# PRICE RIVER COAL COMPANY

Re: Upgrading surface ditches which direct flow to Ponds 012A and 012B  
at Castle Gate

DESIGN FOR 10-YEAR, 24-HOUR STORM PEAK FLOW IN TWO DITCHES AT CASTLE GATE

PROPOSED CONFIGURATION  
DITCH A OR B  
CASTLE GATE PREP  
PLANT  
(SCALE: 1" = 3')

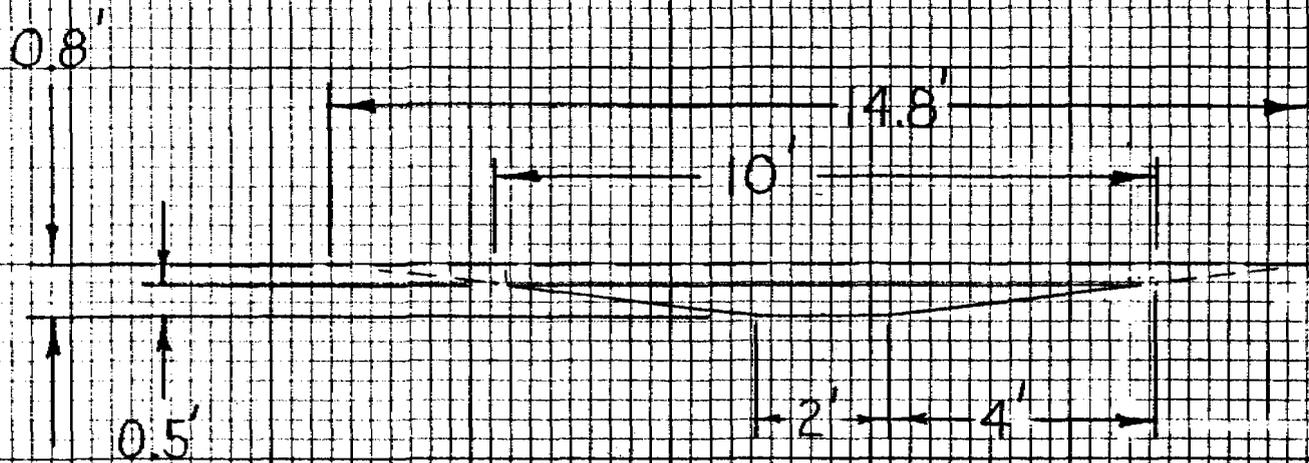
The designs now provided relate to the need to further upgrade Ditch 'B' due to the changes in drainage pattern associated with modifications of the thickener overflow pond. The design provides equal capacity in Ditch 'A' and 'B' for their combined drainage area. The proposed capacity is almost quadruple that needed but it is difficult to construct a ditch much smaller with the equipment at hand.

The configuration proposed will alter in the last 500 feet of Ditch 'B' to a deeper, more narrow structure similar to the dimensions shown for cross section No. 6.

In case either would have to carry total flow, design typical for 5.6 cfs - both ditches.

*PROPOSED CONFIGURATION*

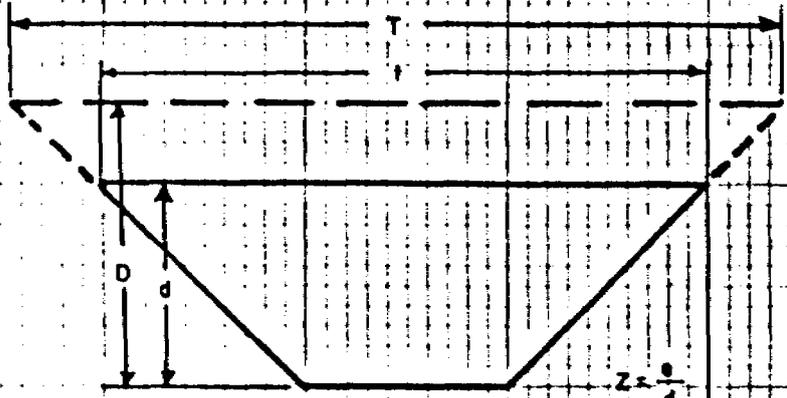
*Rate calc incorrect*
